ORIGINATION FORM

Proposed Revisions to a Standard Plans Index

Index Number: 430-001

Index Title: Miscellaneous Drainage Details

LIMITS OF VARIABLE FRONT SLOPES AT DRAINAGE STRUCTURES

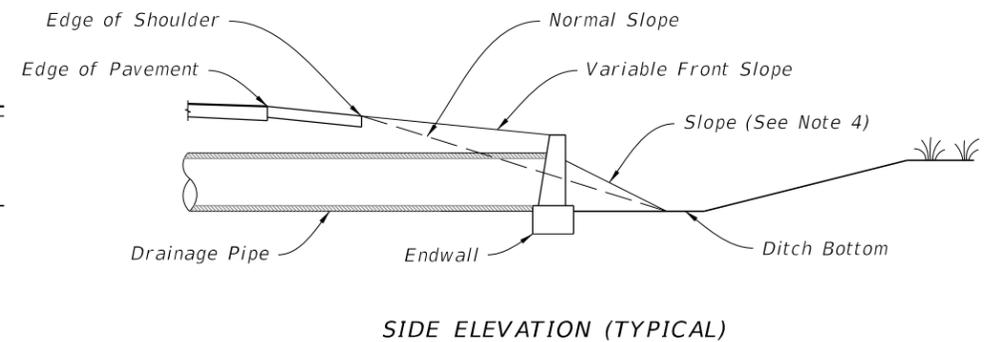
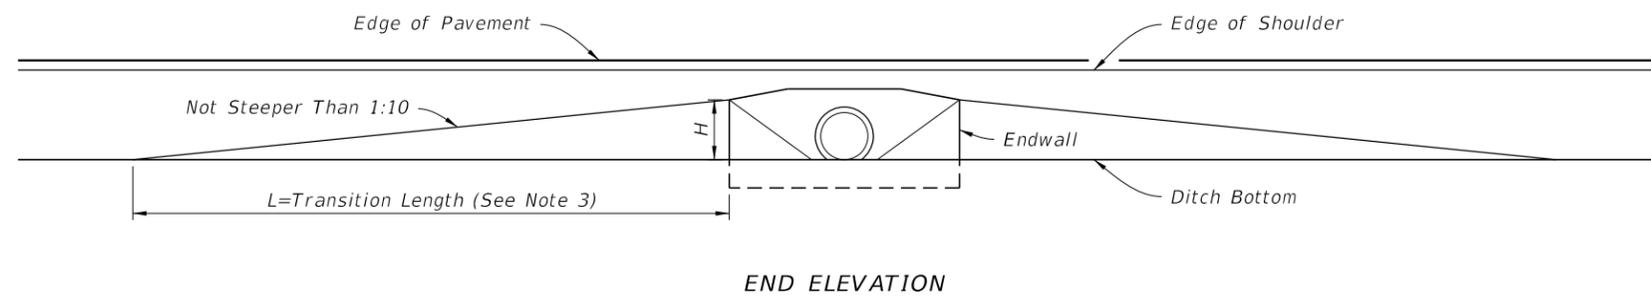
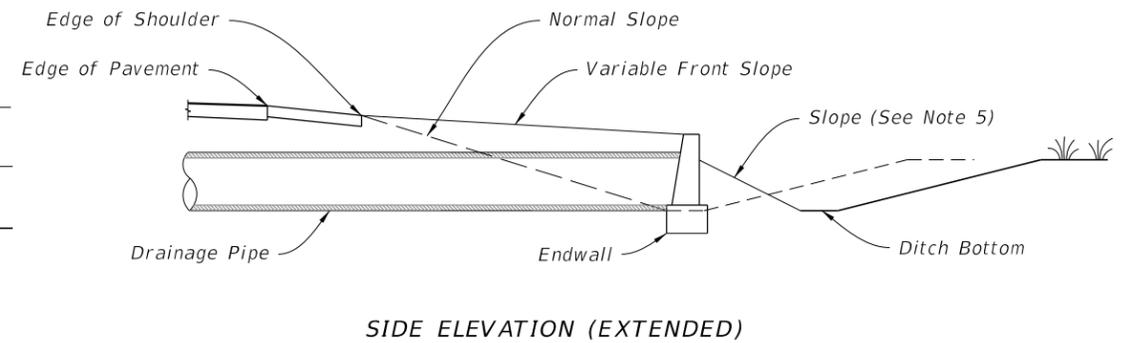
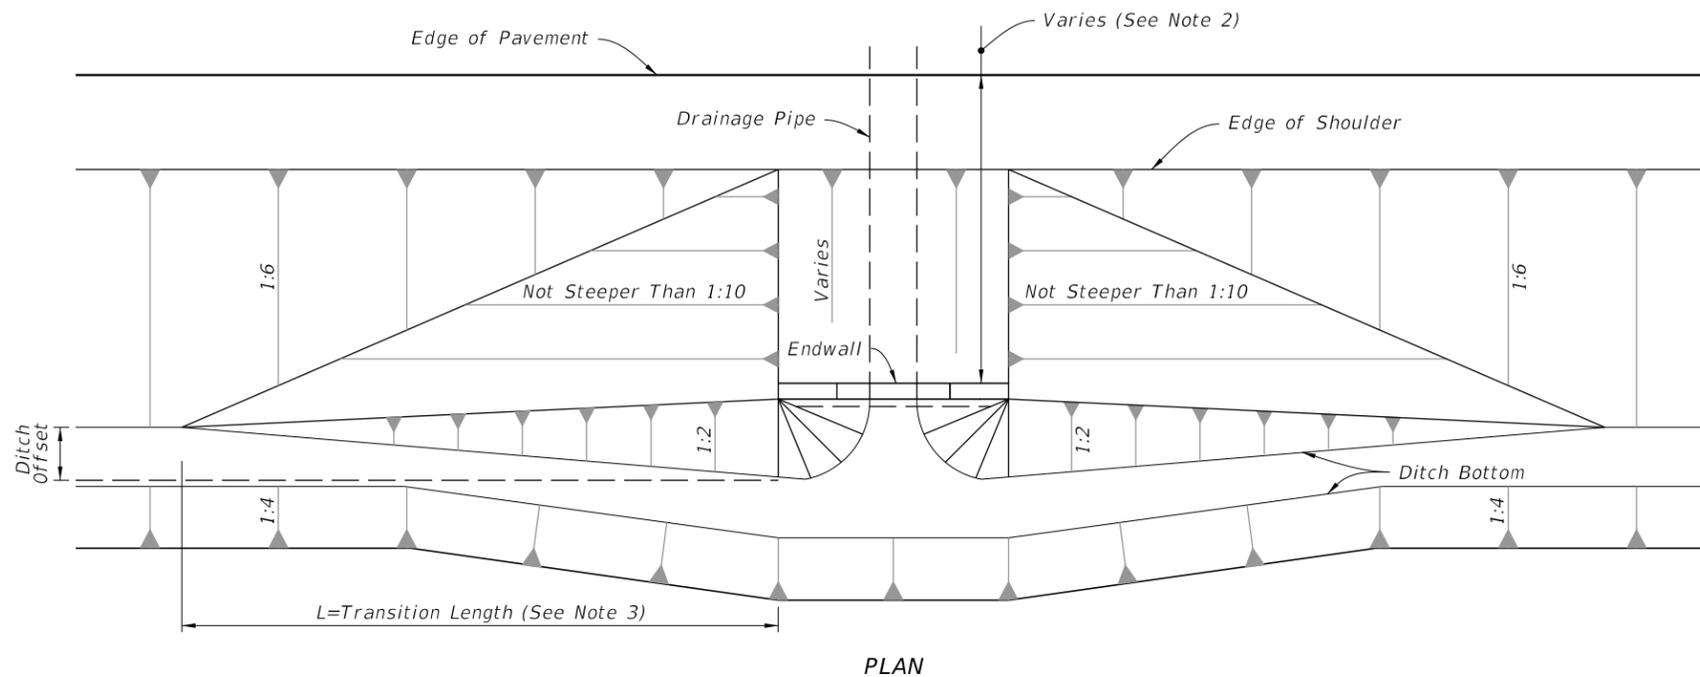
Sheet 1: Updated Table of Contents to reflect title change on Sheet 3.

UPDATED TITLE: Geotextile

ROUND AND ELLIPTICAL CONCRETE PIPE JOINT

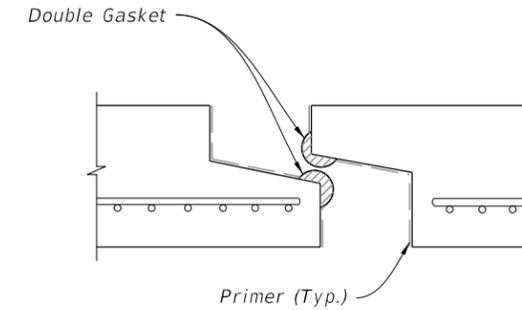
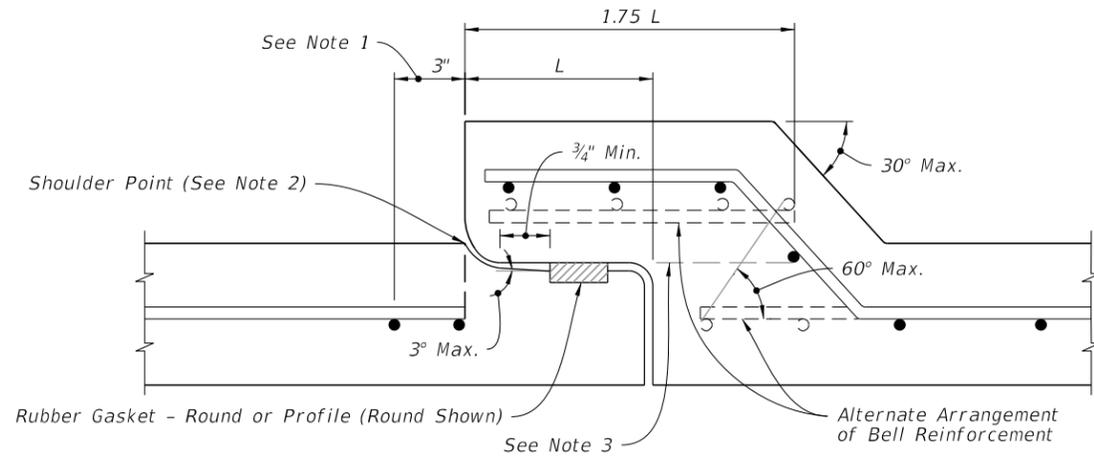
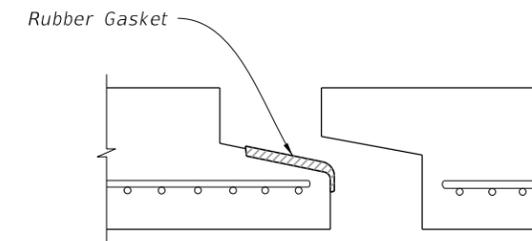
Sheet 2: Updated Note 1 - "Filter Fabric" to "Type D-3 Geotextile"...

1. ~~Filter Fabric Jacket~~ is required on both type of joints.
2. Details shown before pull-up.

UPDATED Note 1: Type D-3 Geotextile

FILTER FABRIC JACKET, CONCRETE JACKET, AND PIPE PLUG

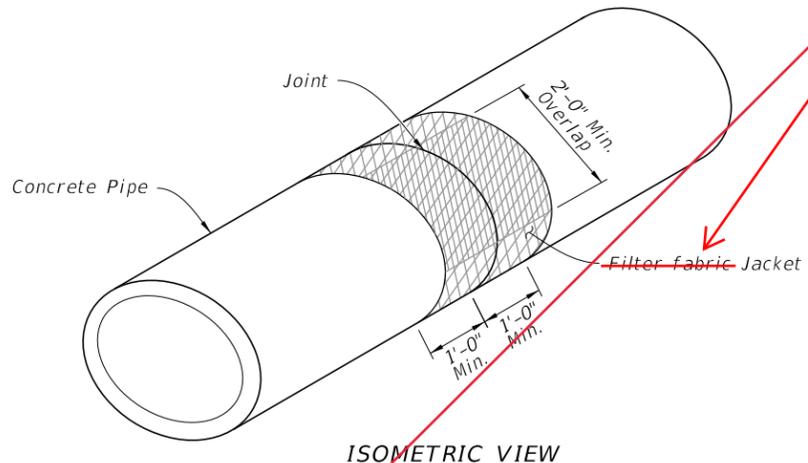
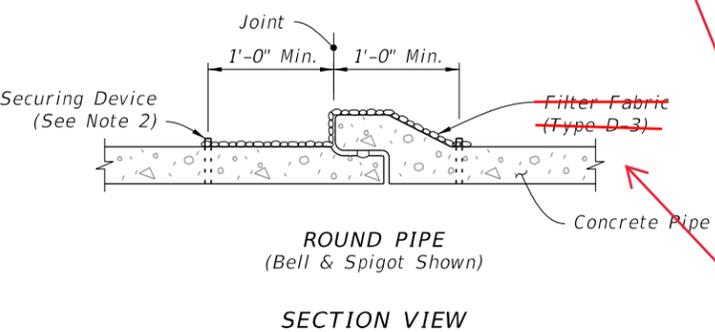
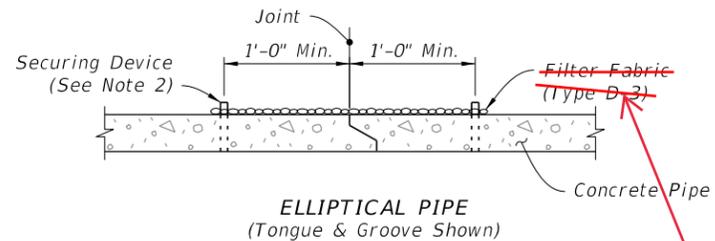
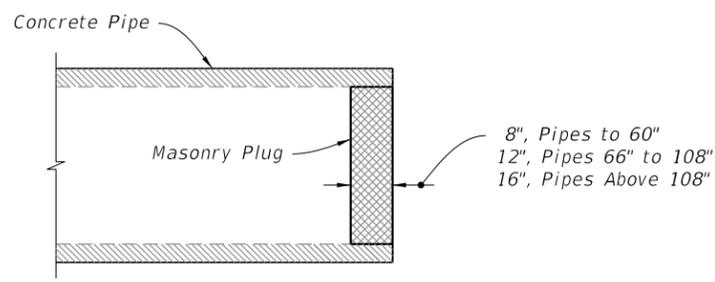
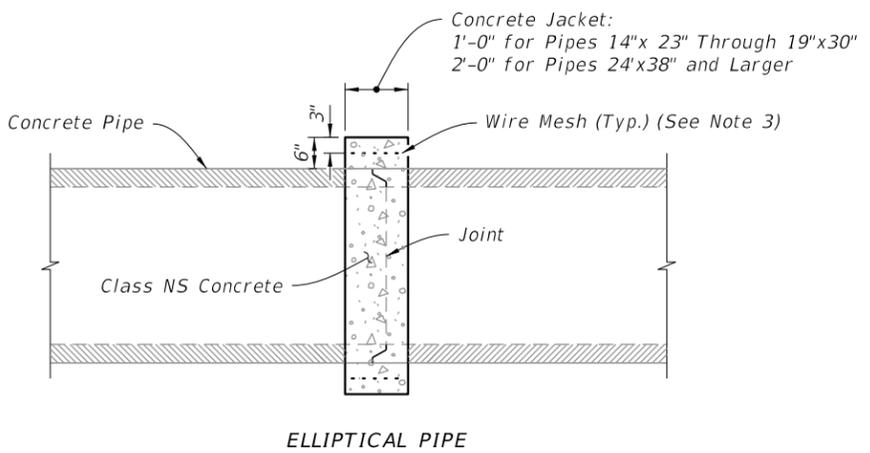
Sheet 3: Updated Note 2 "Install Type D-3 geotextile in accordance with Specification 514. Install securing device to hold the geotextile jacket on to the pipe." ; Changed all references of "Filter Fabric" to "Geotextile".

CHANGED: Geotextile

UPDATED Note 2: Install Type D-3 geotextile in accordance with Specification 514. Install securing device to hold the geotextile jacket on to the pipe.
